**DEVIATION REQUEST
AND DECISION FORM IN
ASSOCIATION WITH
A REQUEST FOR A PUD
MODIFICATION FROM
THE ECM**

Project Name : MEADOWBROOK PARK

A deviation from the standards of or in Section **2.1.3 Standard Drawings, 2.3 ROADWAY DESIGN; & 2.4 ROADWAY ACCESS CRITERIA** of the Engineering Criteria Manual (ECM) is requested.

STANDARD COUNTY URBAN LOCAL (LOW VOLUME) CROSS SECTION:

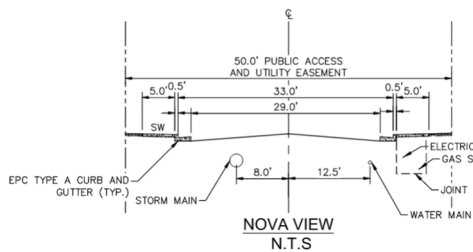
Please also provide the urban local road cross section for comparison. Per the ADT to be generated at least one roadway will not meet the 300 ADT threshold of the urban local low volume road.

PROPOSED MEADOWBROOK PARK PUD PRIVATE ROAD CROSS SECTIONS

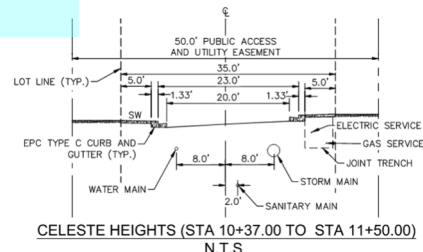
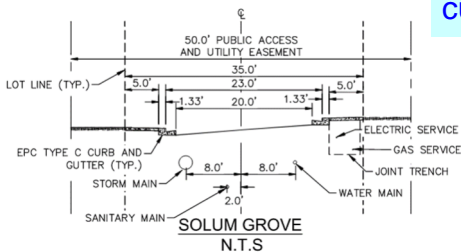
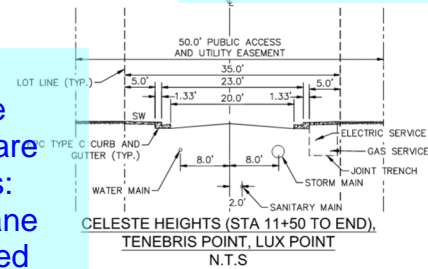
Please list the deviations from the standard that you are requesting such as: pavement width, lane width, superelevated roadway and roadway termination without a cul-de-sac.

Please indicate also indicate that a 29' paved width as opposed to 30' is also proposed in one of the roadway cross sections. Please also discuss justification for the other deviations from the County standard cross section. A written endorsement from the fire district will be required for the roadway terminations and the reduced paved width of 20ft. Also please discuss the fire lanes that will be proposed.
